WILLIAMSON COUNTY, TEXAS

CHANGE ORDER NUMBER: 1

Project:	<u>1811-278</u>
Roadway:	<u>Forest North-Anderson Mill</u>
CSJ Number:

3F: County Convenience. Additional work desired by the County. This Change Order adds drainage improvements on Tottenham Court at the County's request and provides the final balancing of unused items for the 8-inch water line relocation.

#2

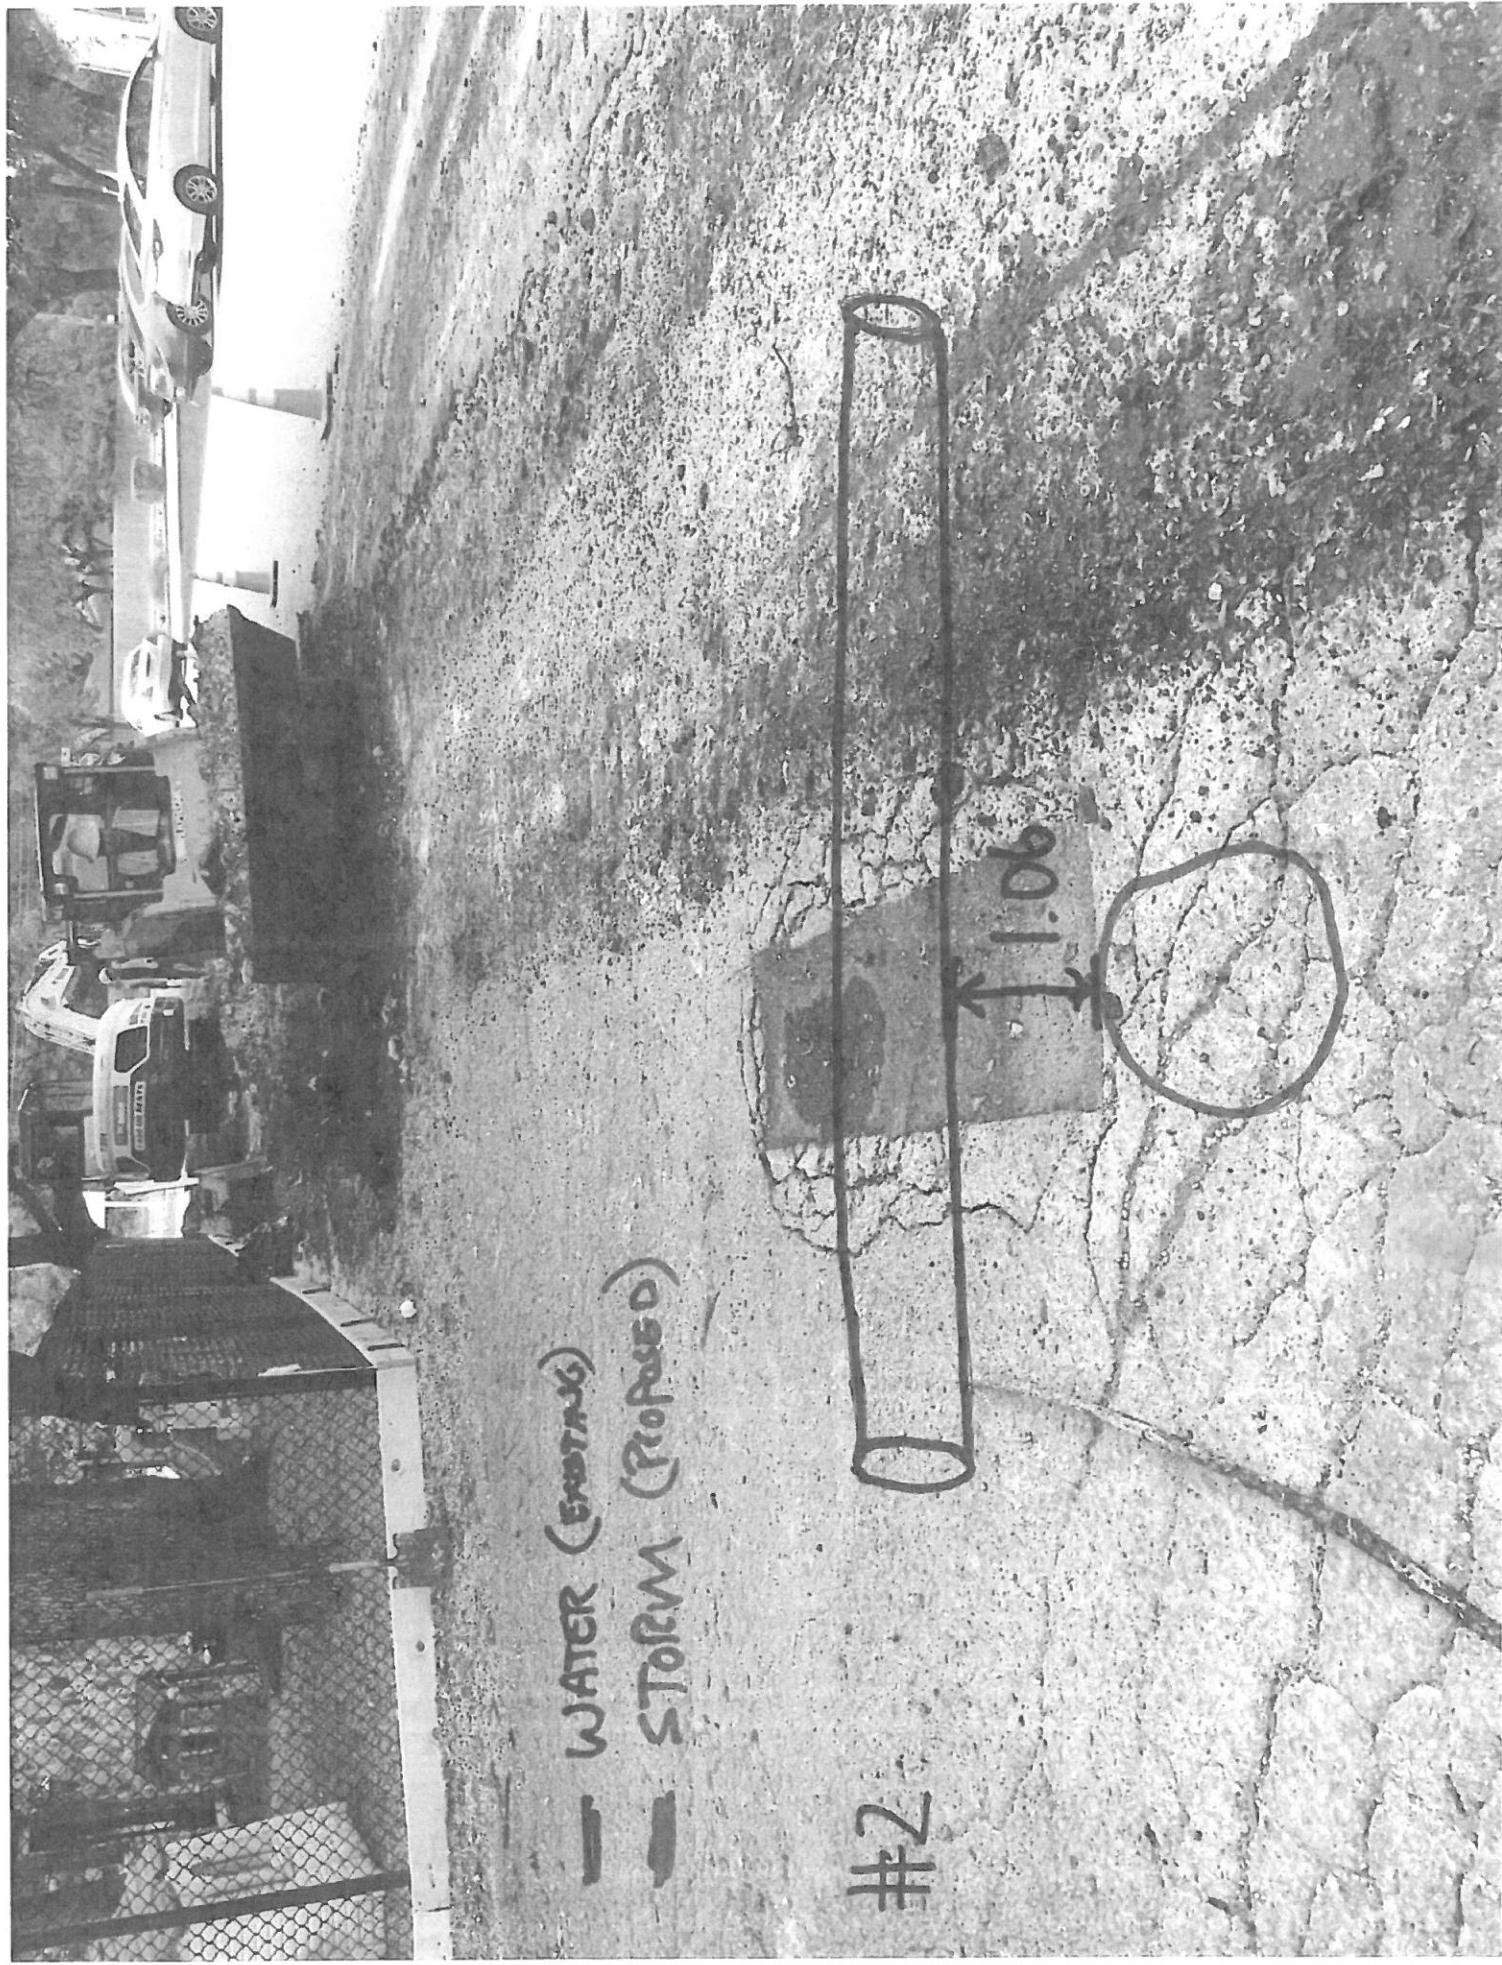
Can all proposed waterline relocation/installation be removed from the contract due to the current separation distances shown on the attachments? Photo #1 references Sheet C-103. Photo #2 references Sheet C-104. Photo #3 references Sheet C-102 at Station 1+42. Photo #4 references Sheet C-102 at Station 2+25.

On Pothole 2, Alley behind pre school:

Bottom of existing waterline - 929.82
Top of proposed storm- 928.76
Difference- 1.06'

AWU agrees that the lines are determined to not be in conflict and so can be removed from the scope of the project.

#3

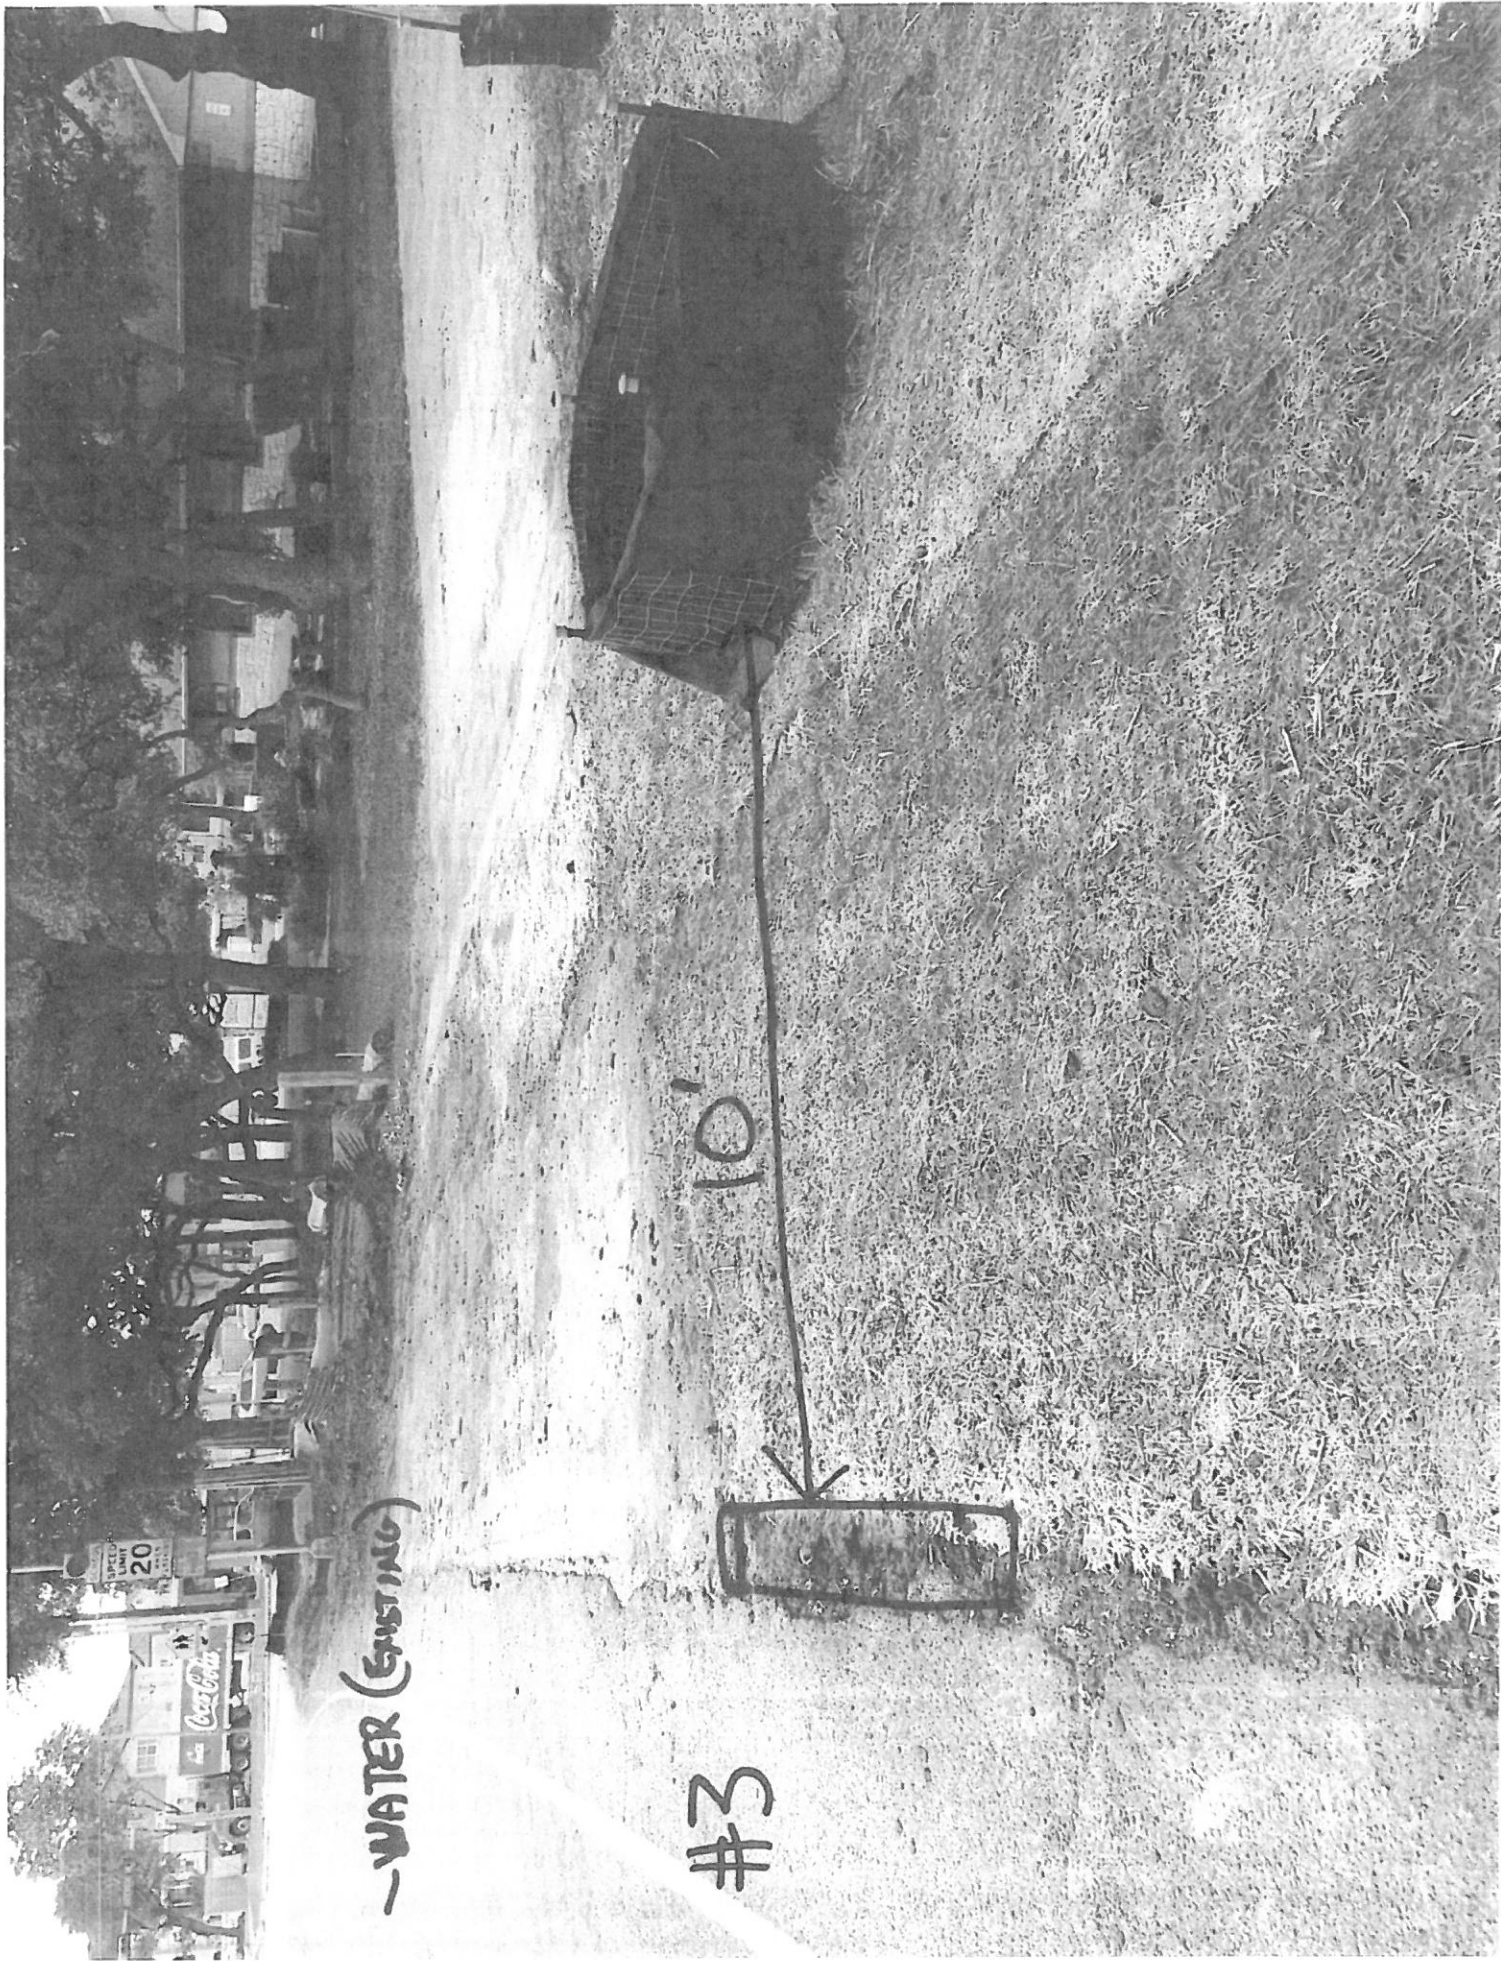
Pothole 3: Waterline, Broadmeade and Roxboroough, between costumers driveways

Trench: 3'x4'x5'
T.O.P: 922.20
B.O.P: 921.50

#4

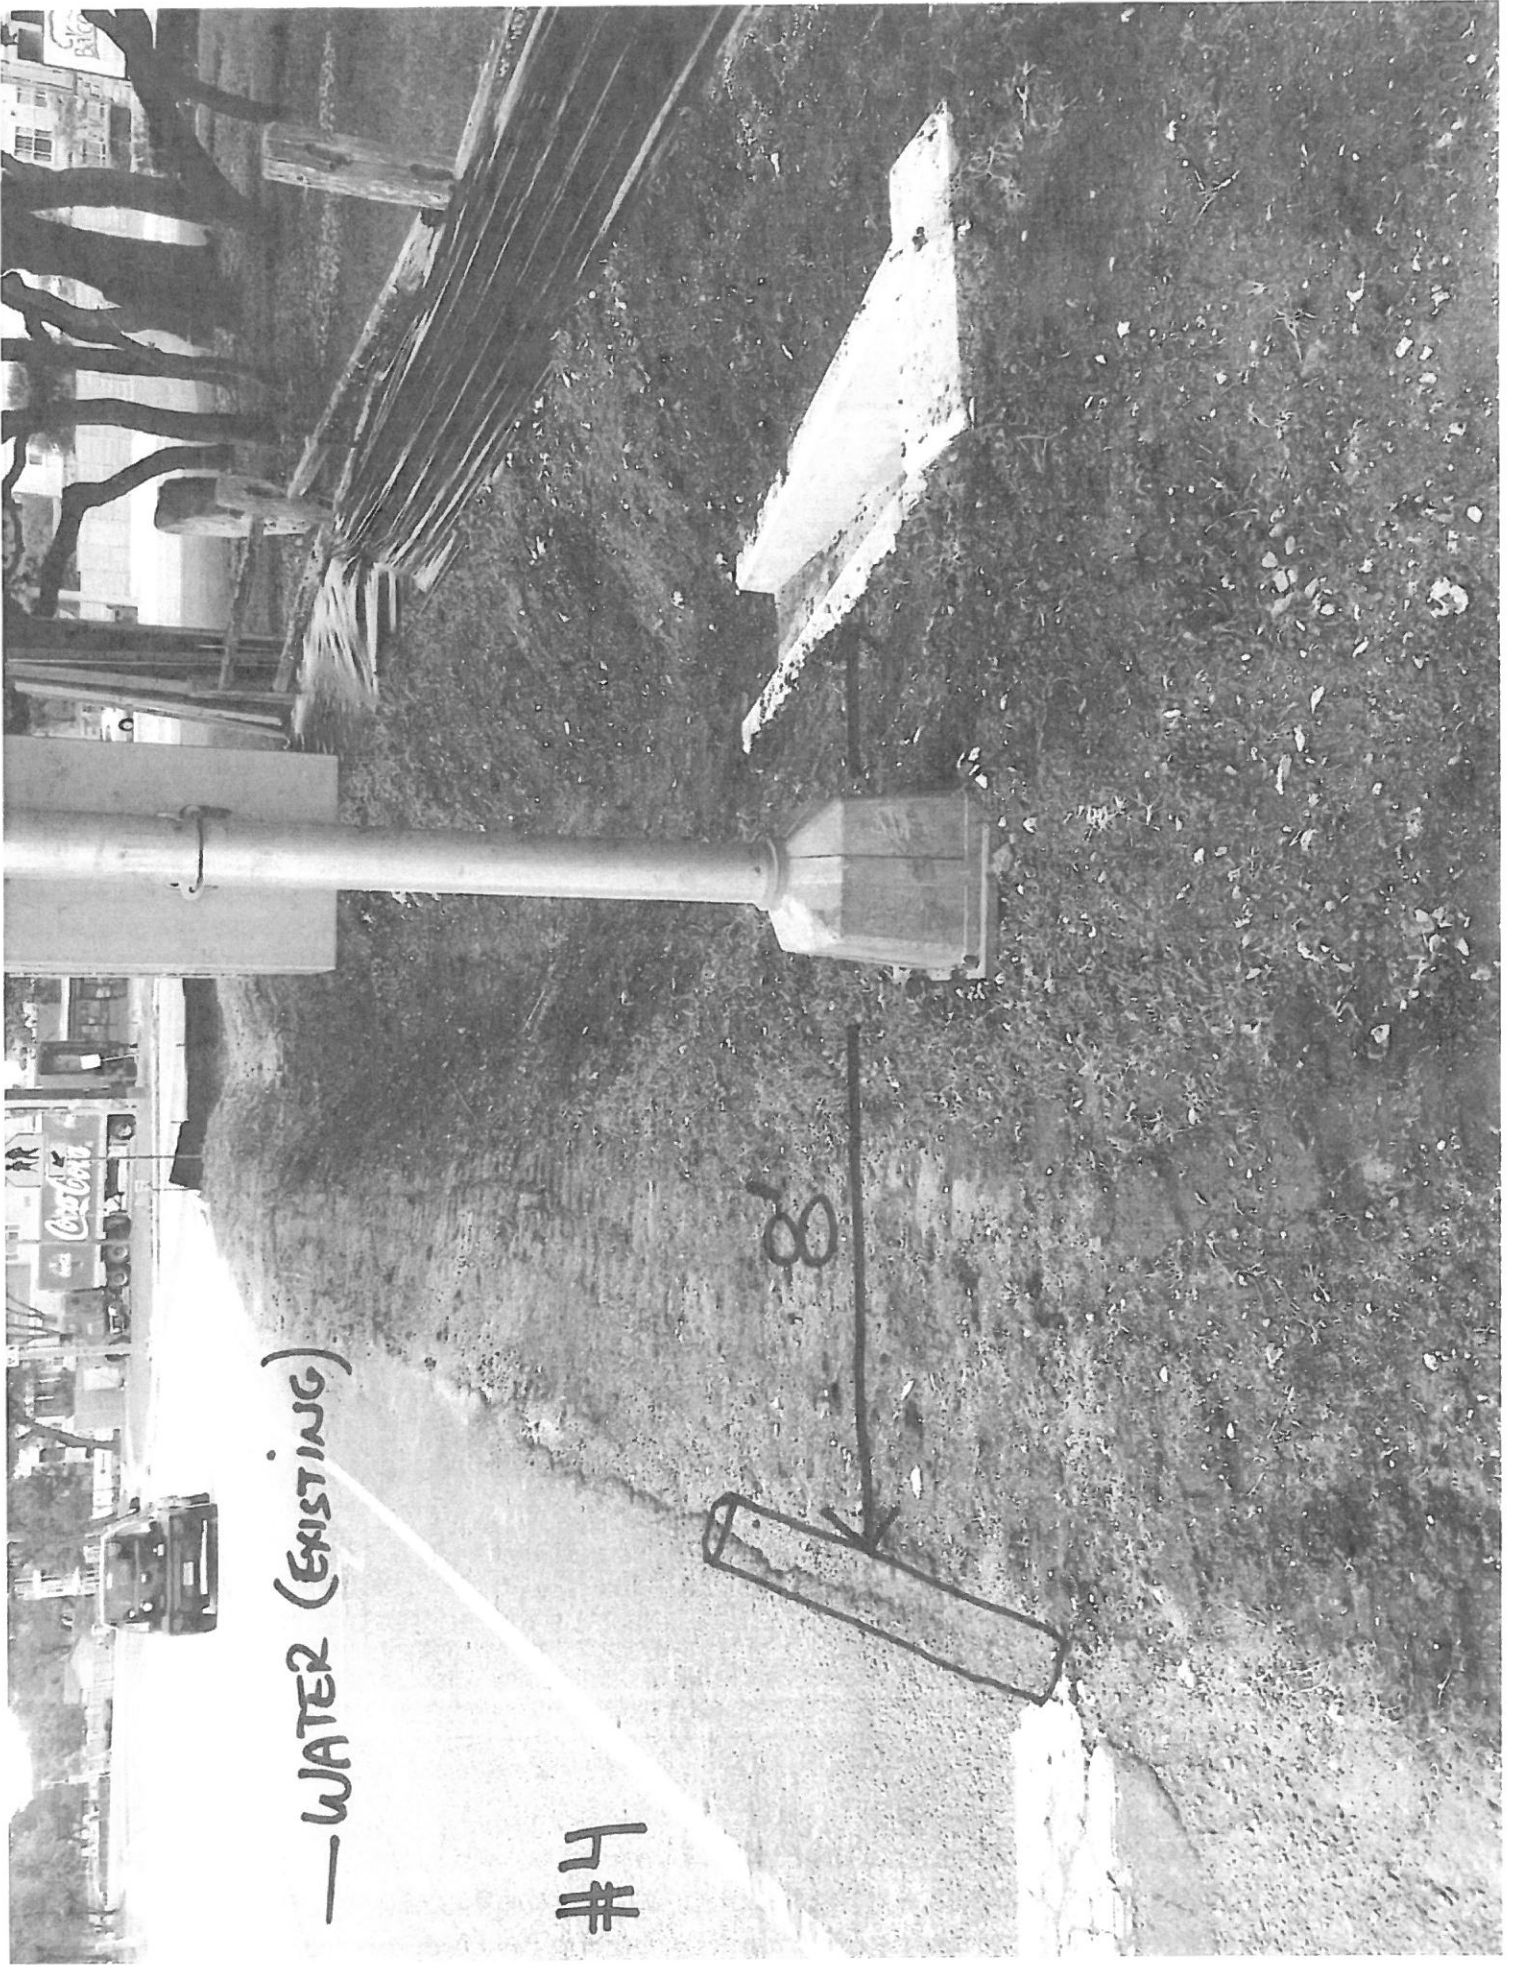
Pothole 4: Waterline, Dentist office between fence and Asphalt

Trench: 5'x4'x4'
T.O.P: 922.15
B.O.P: 921.45
